Department of Community Planning and Economic Development
Variances and Site Plan Review
BZZ-6404

Date: February 3, 2014

Address of Property: 1218-22 Como Avenue SE

Proposed Use: Construction of an 8-unit multi-family residential building.

1 LANDSCAPE PLAN
1" = 20'-0" north

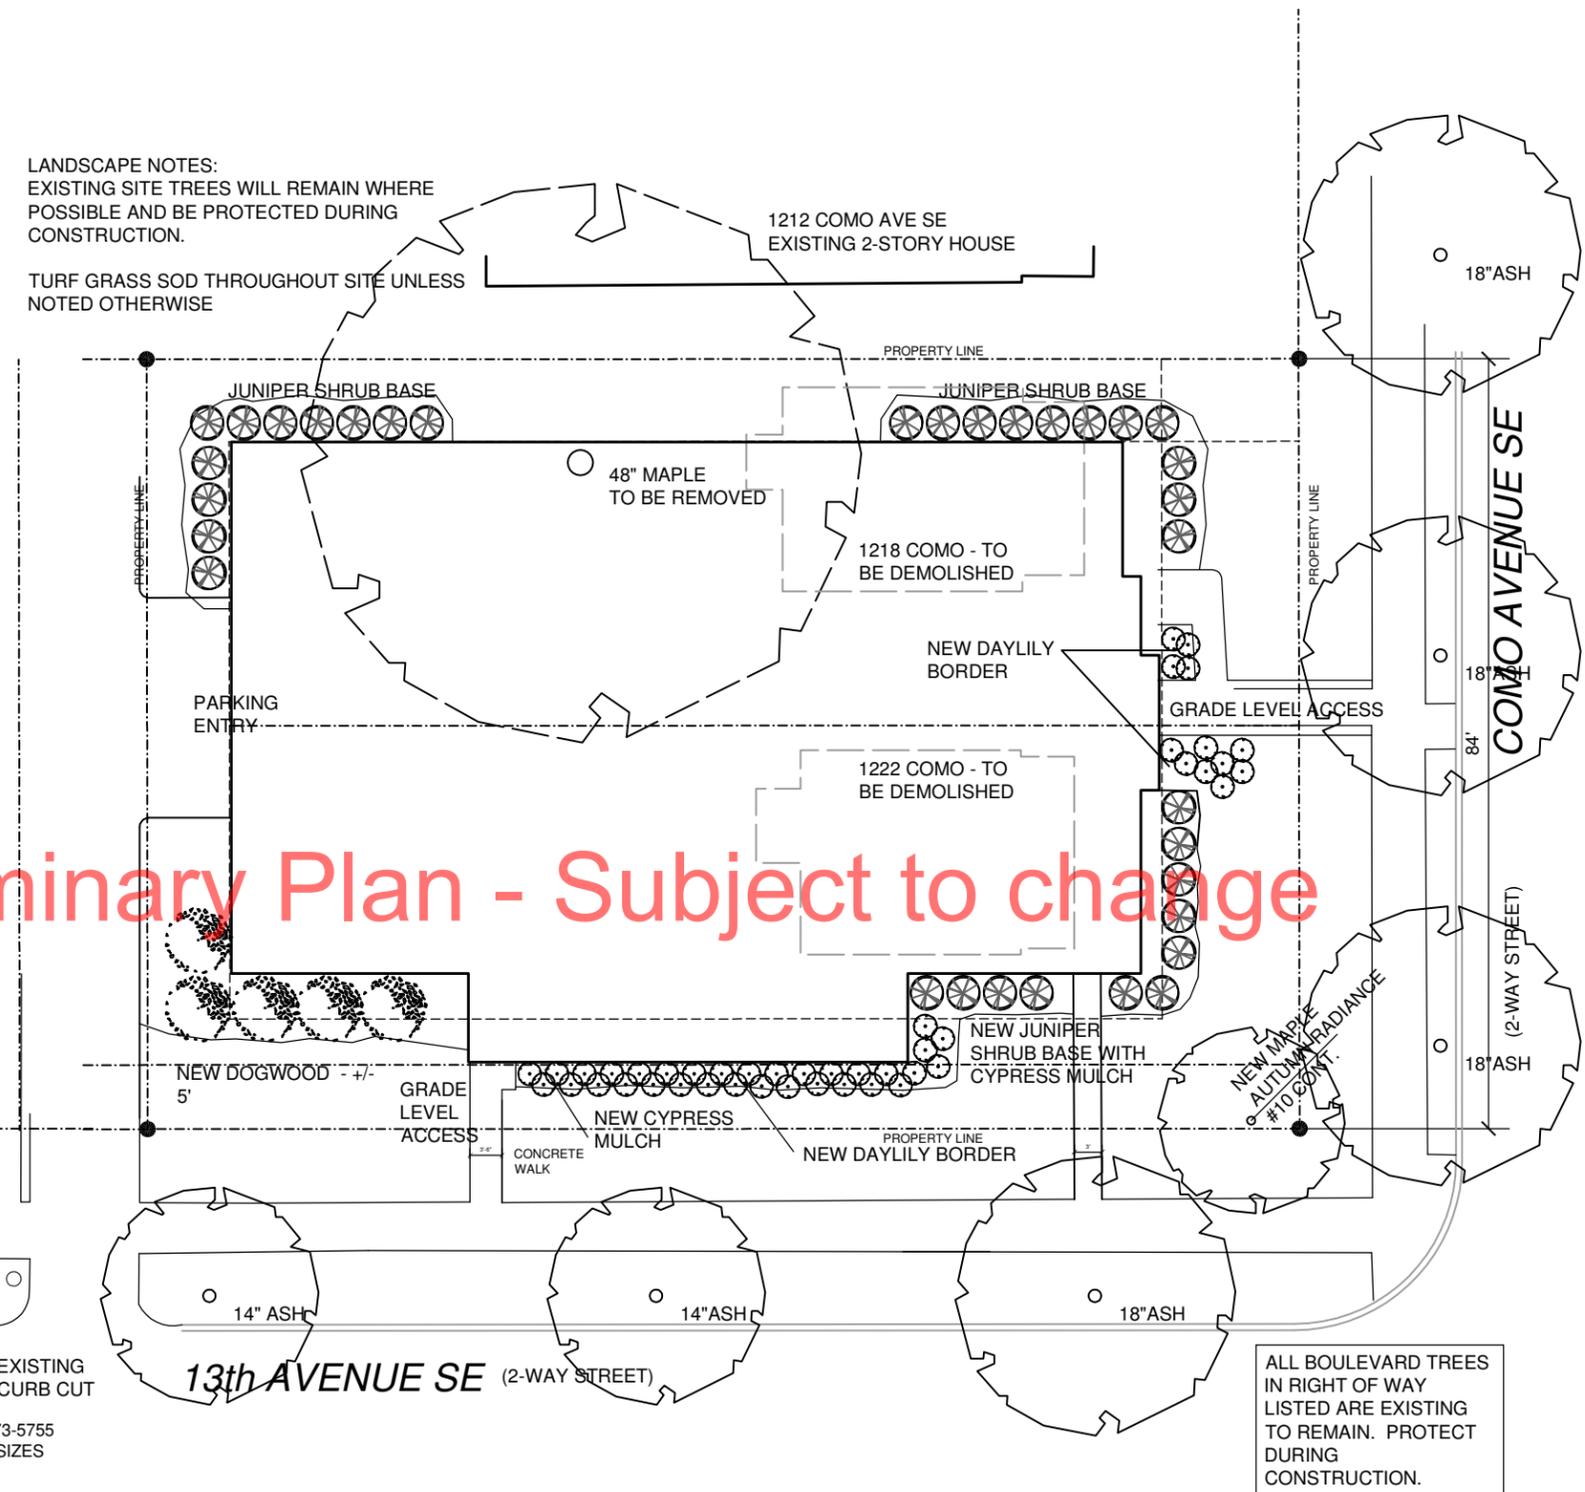
The applicant is proposing 3,938 square feet of landscaping on site, equivalent to 90 percent of the site not occupied by building. The landscape plan includes one on-site canopy tree, three ornamental trees, 33 shrubs and perennials. There are six existing canopy trees in the

right-of-way directly adjacent to the site that will be retained. Alternative compliance has been requested for the number of canopy trees. All other landscaping requirements have been met.

Alternative compliance is requested for the minimum tree planting requirement. A minimum of two canopy trees are required to be provided on site and only one is proposed. Staff does not recommend granting alternative compliance for this requirement. As a condition of approval, one additional canopy tree will be required on site.

4. The louvers proposed on the west elevation shall be decorative and shall be modified so that the location and size of the louvers align with the double-hung windows on the third floor.
5. Two canopy trees shall be provided on site, in compliance with Section 530.160 of the zoning code.

4 SIDE ELEVATION (INTERIOR YARD)
Scale: 1/16"= 1'-0"

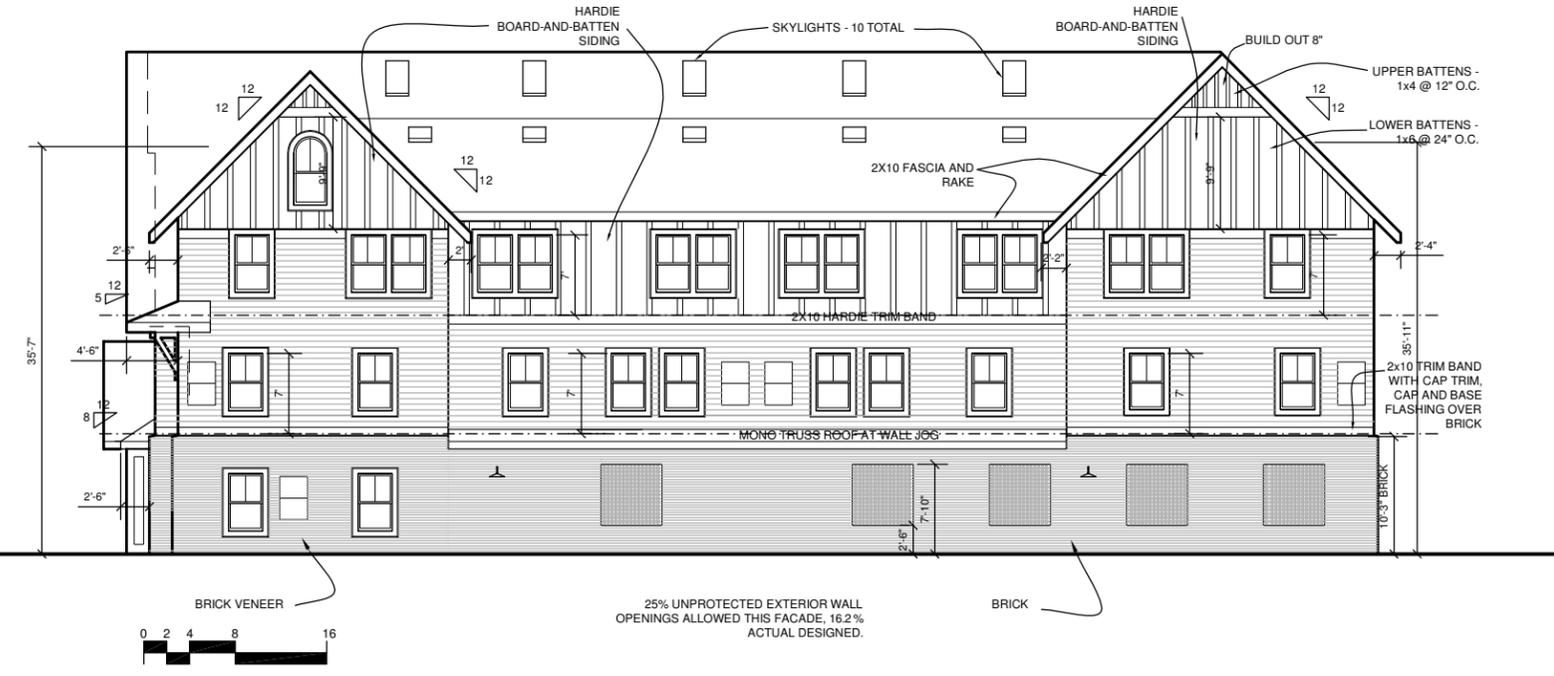
The building does not contain any blank walls that exceed 25 feet in length. On the first floor of the west elevation, the applicant is proposing painted metal louvers to break up the blank wall. These louvers will be designed to accommodate vines. As a condition of approval, staff is recommending that these louvers be decorative in the event that the vines do not thrive. Similar louvers are proposed on the east and south elevations. Additionally, staff is recommending that the location and size of the louvers on the west elevation be modified to align with the double-hung windows on the third floor. This recommendation is made to provide for openings that are more or less evenly distributed.
